Title of Change:	AR0237SR Datasheet Update
Effective date:	08 Mar 2020
Contact information:	Contact your local ON Semiconductor Sales Office or <Sonya.Yip@onsemi.com>
Type of notification:	This Product Bulletin is for notification purposes only. ON Semiconductor will proceed with implementation of this change upon publication of this Product Bulletin.
Change Category:	Documentation Change
Change Sub-Category(s):	Datasheet/Product Doc change

The AR0237SR Datasheet has been updated with new information. These changes do not affect form, fit, or function of the product.

Figure 7. Quantum Efficiency - RGB Packaged Part

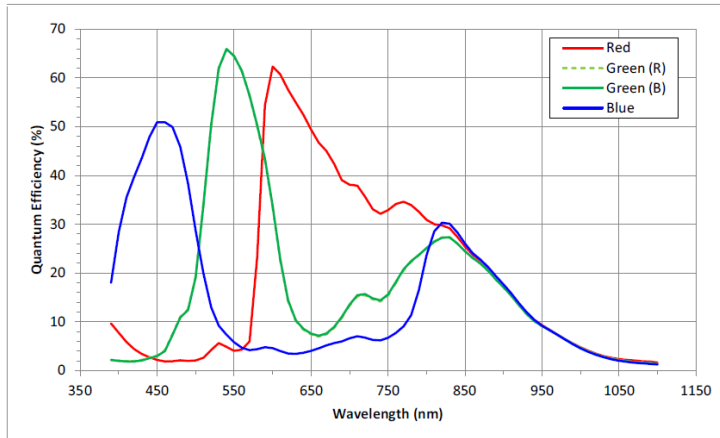
2. Replaced Figure 7, "Quantum Efficiency- RGB Package Part" with new figure

Old Figure 7:

Figure 7. Quantum Efficiency - RGB Packaged Part

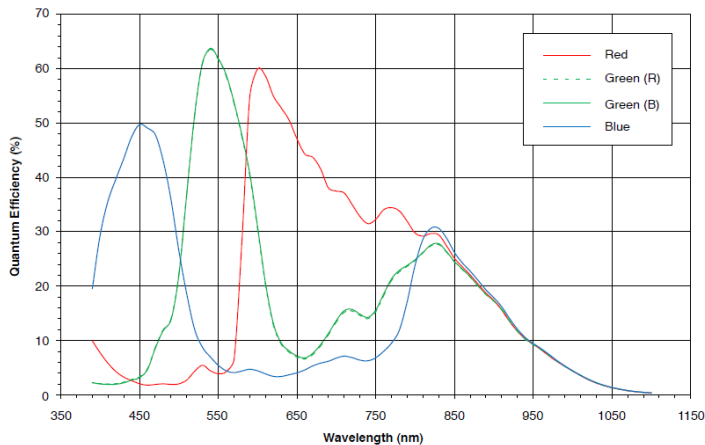
New Figure 7:
